ADDENDUM NO. SEVEN

October 8, 2024

Lamont Park Beautification Project

1650.7012.22

- ① CONCRETE, 4,000 PSI MIN., AGGREGATE 3/8" OR SMALLER, NO SLUMP GREATER THAN 5"
 ② #3 REBAR, 12" O.C. BOTH DIRECTIONS
 ③ 3/4" MINUS CRUSHED ROCK, 4" MIN. DEPTH
 ④ COMPACTED SUBGRADE
 ⑤ ADJACENT 4" THICK CONCRETE WALKWAY ABOVE SKATE PARK BOWL
 ⑥ STEEL COPING AT BOWL RIM, REFER TO DETAIL

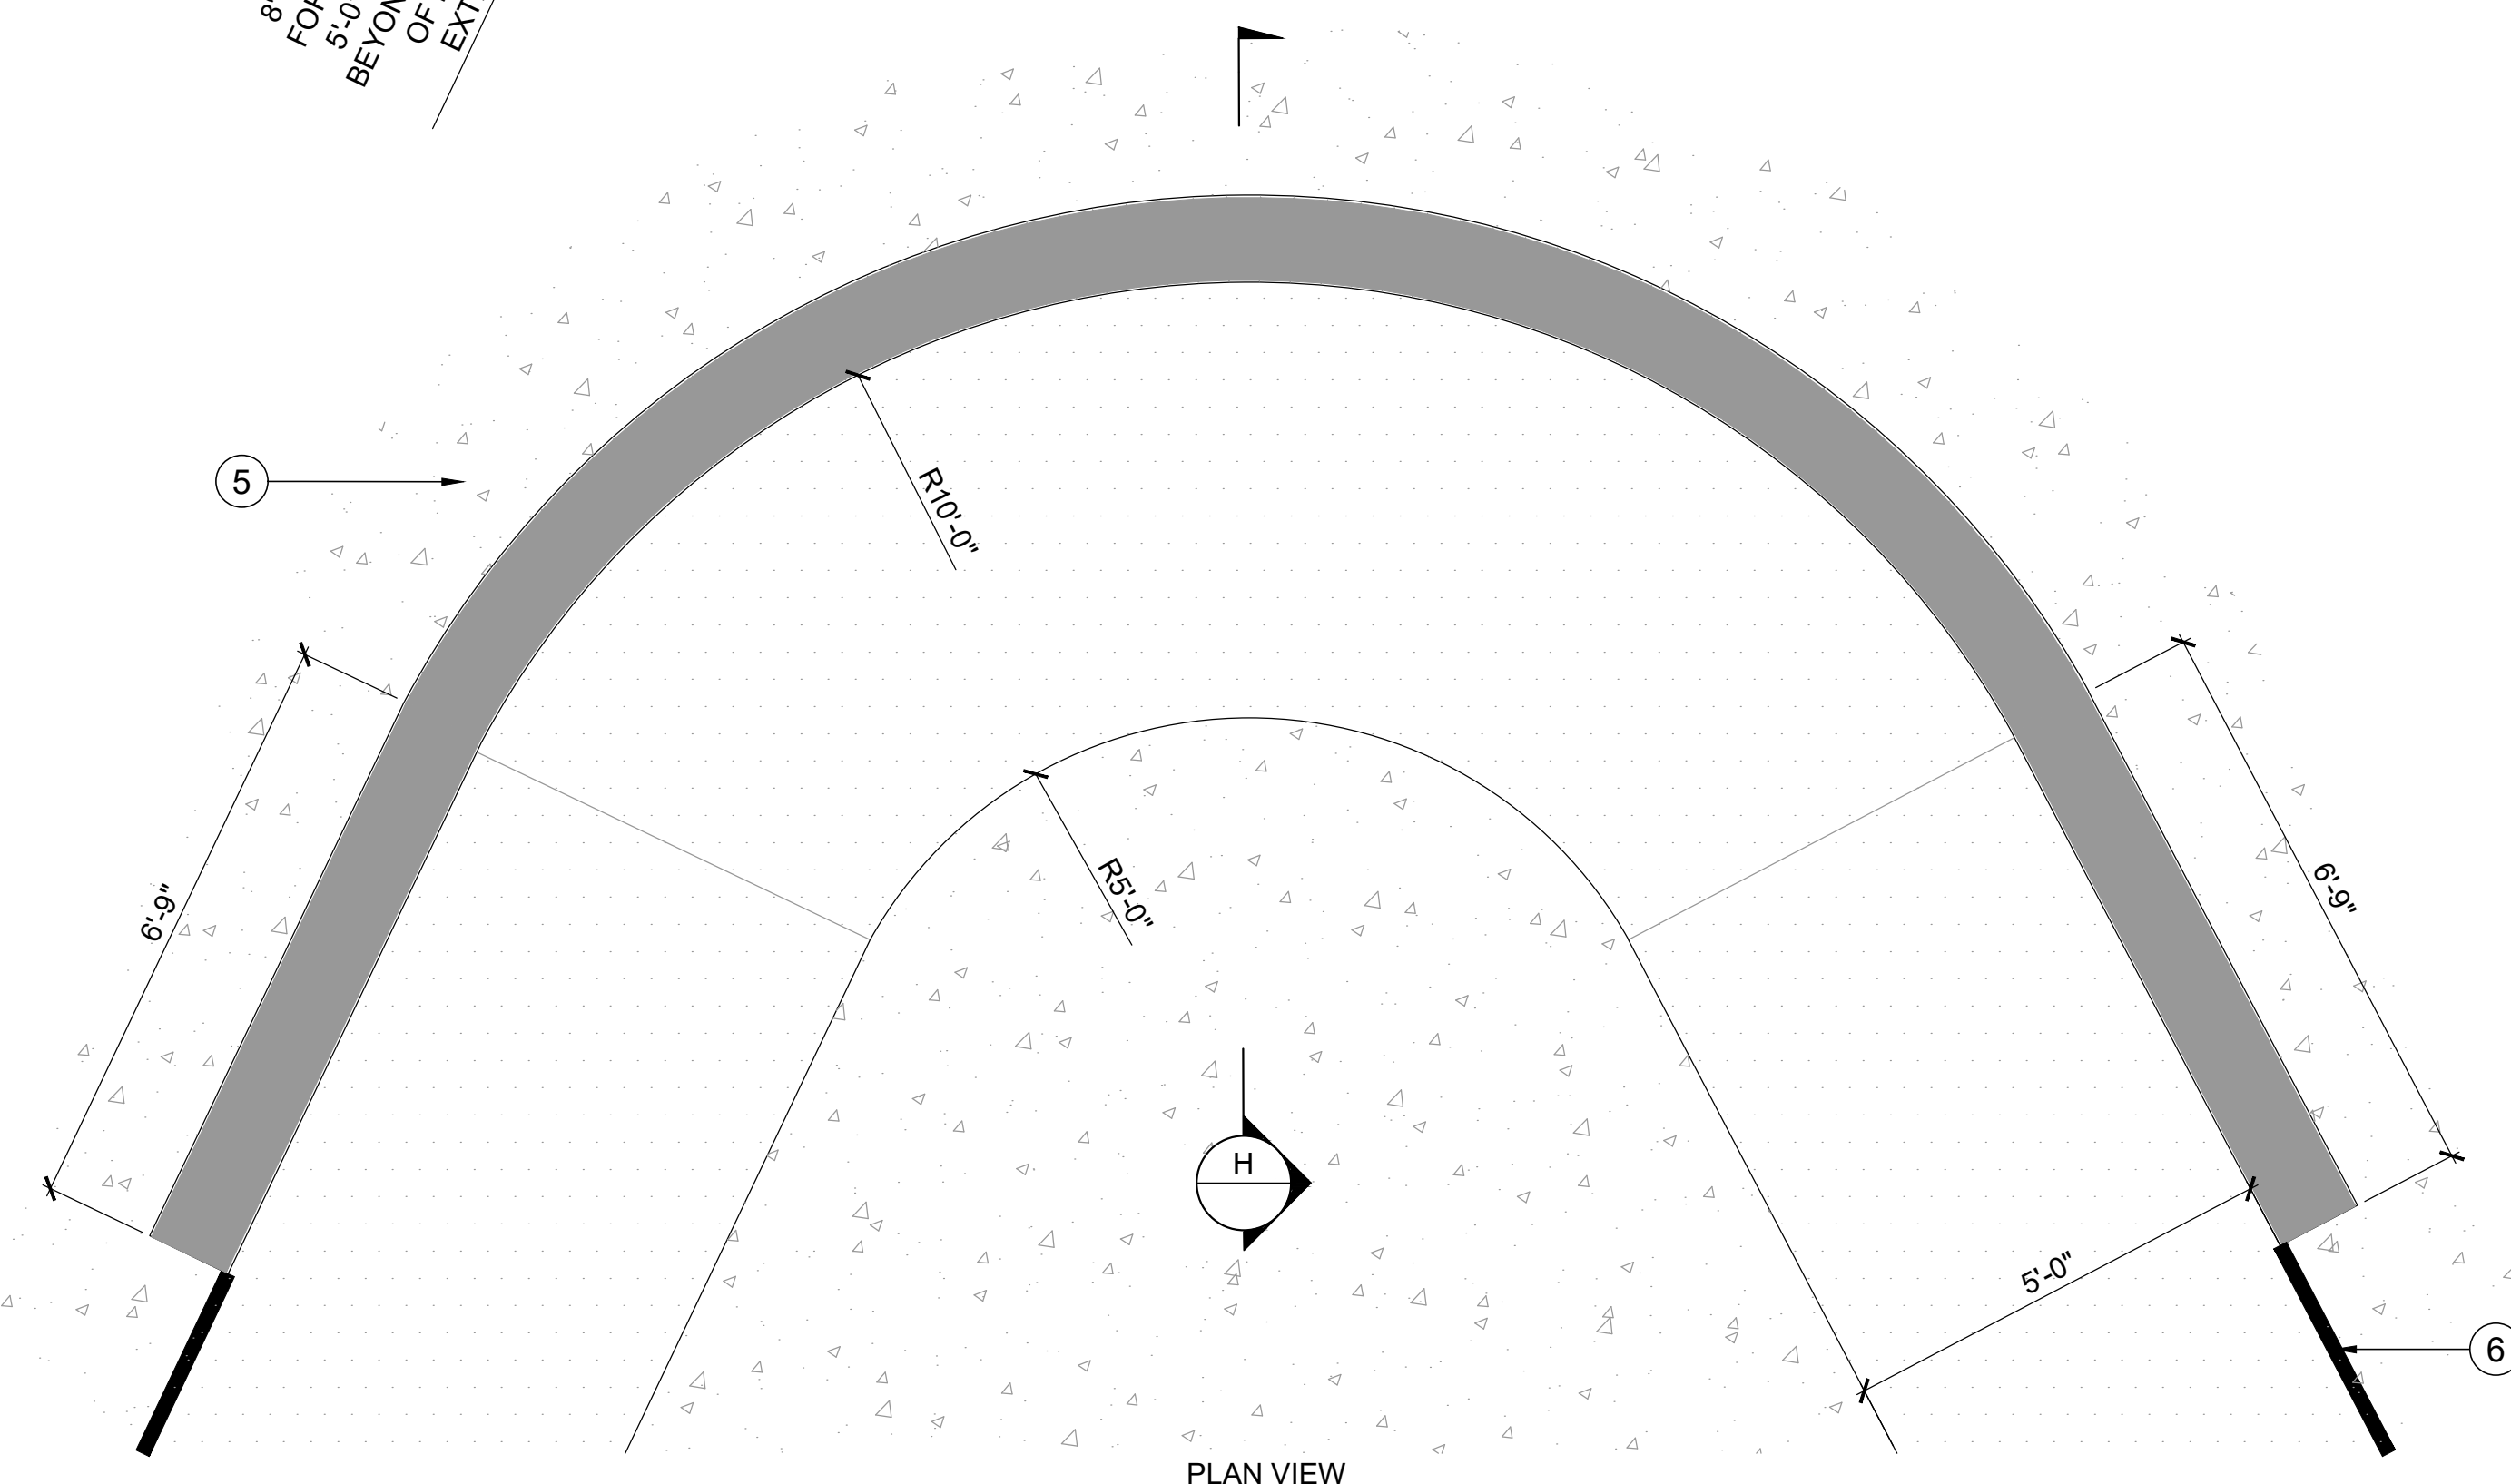
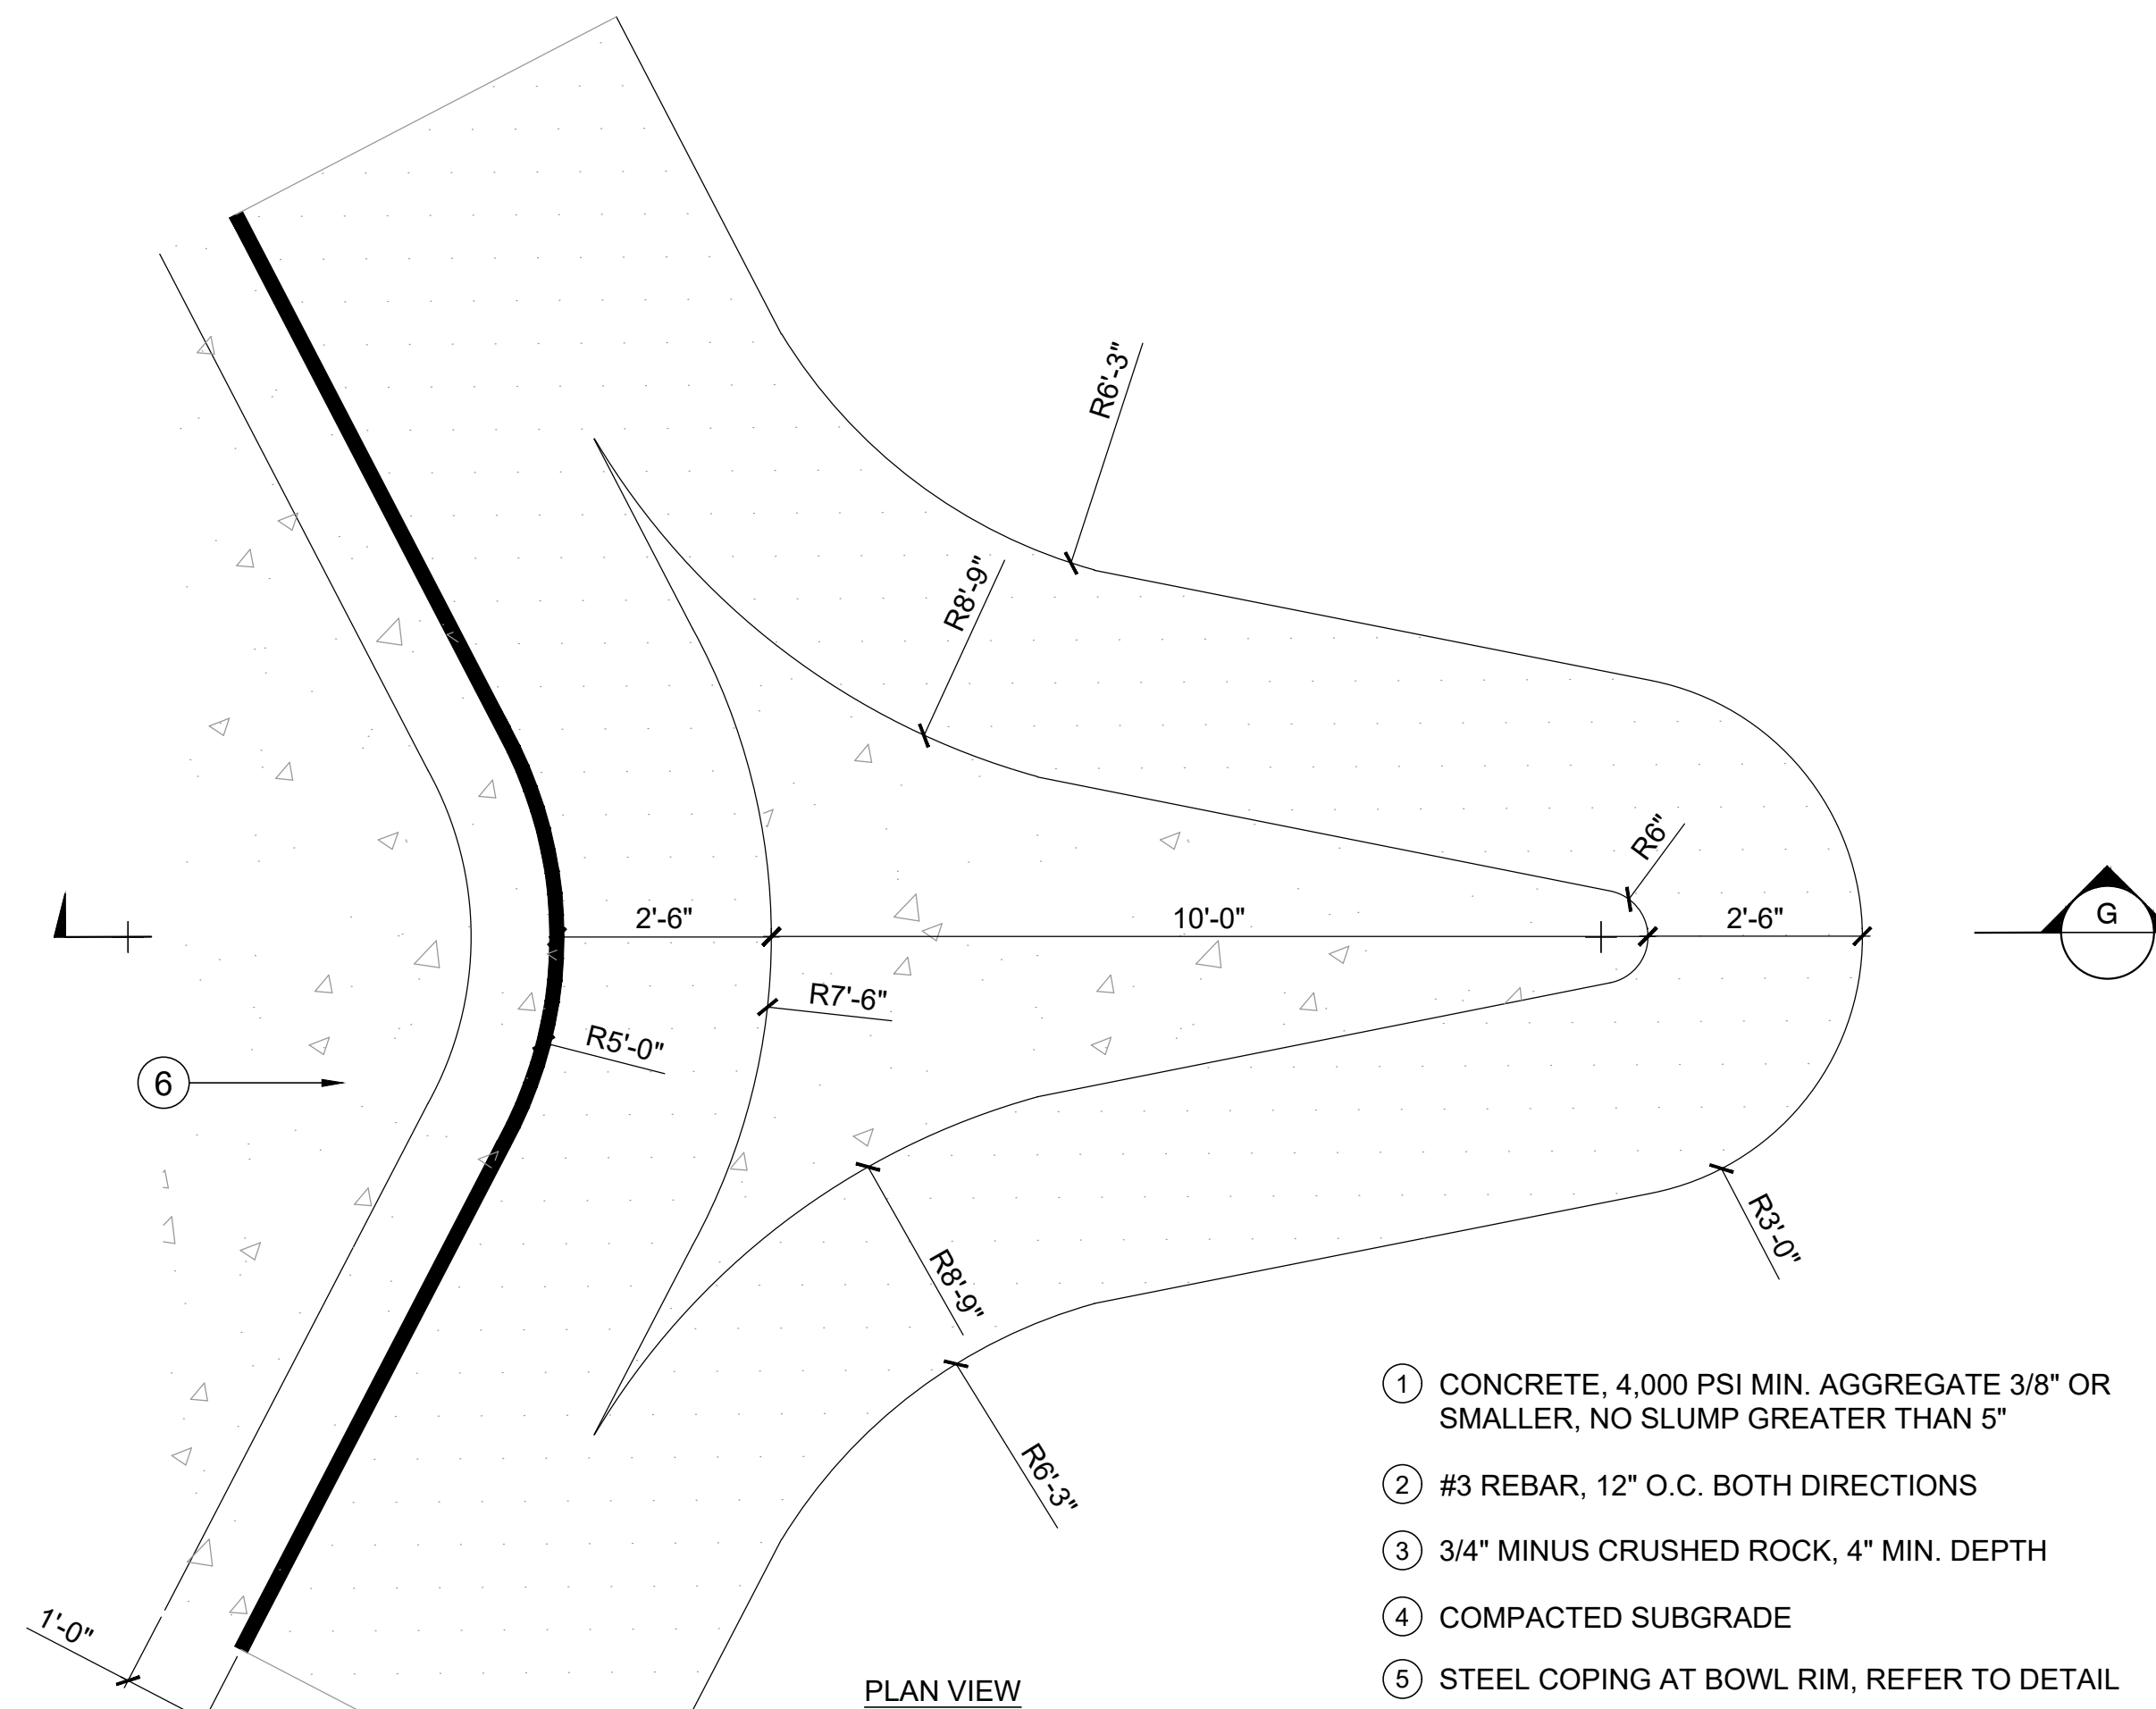
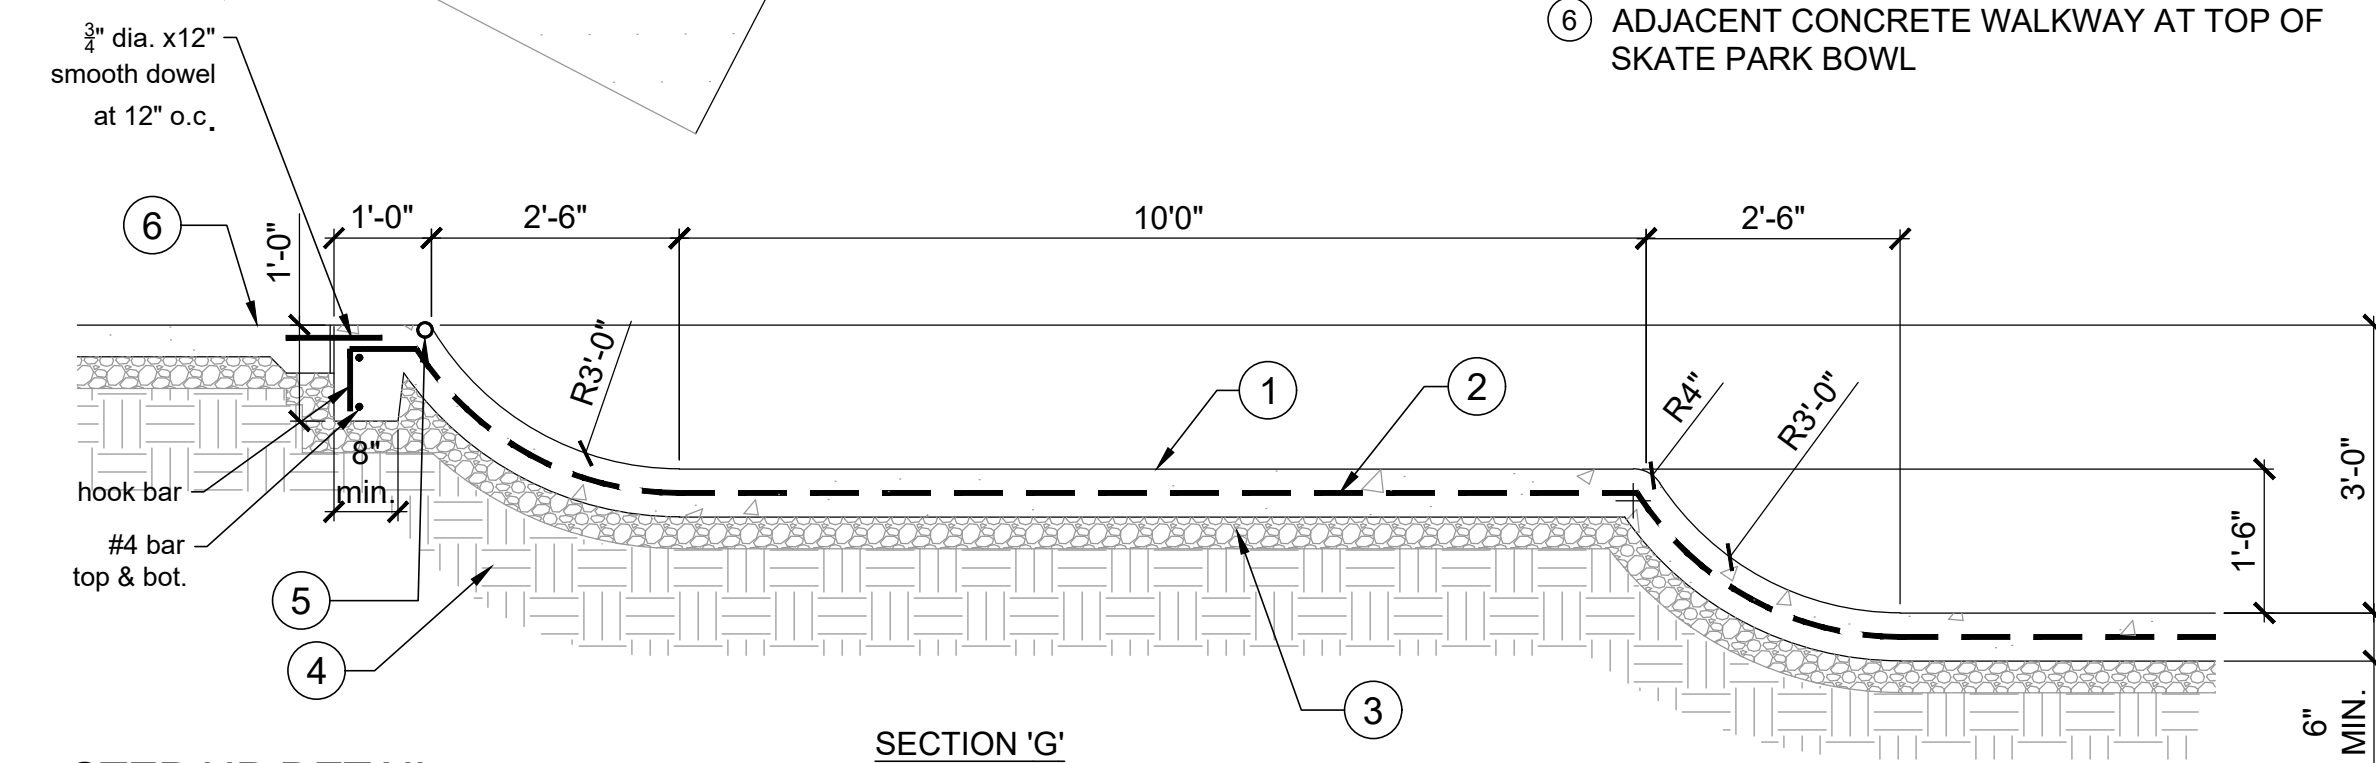
- Item No. 6:** Refer to sheet LCD.09 for details on call out C-04 & C-05.
- Item No. 7:** Shotcrete is acceptable for use on Skate Park.
- Item No. 8:** Refer to attached sheet LCD.05 and replace existing sheet LCD.05 in its entirety. A thickened beam and dowels will be added at the top of the skatepark wall. Refer to details on attached LCD.05.
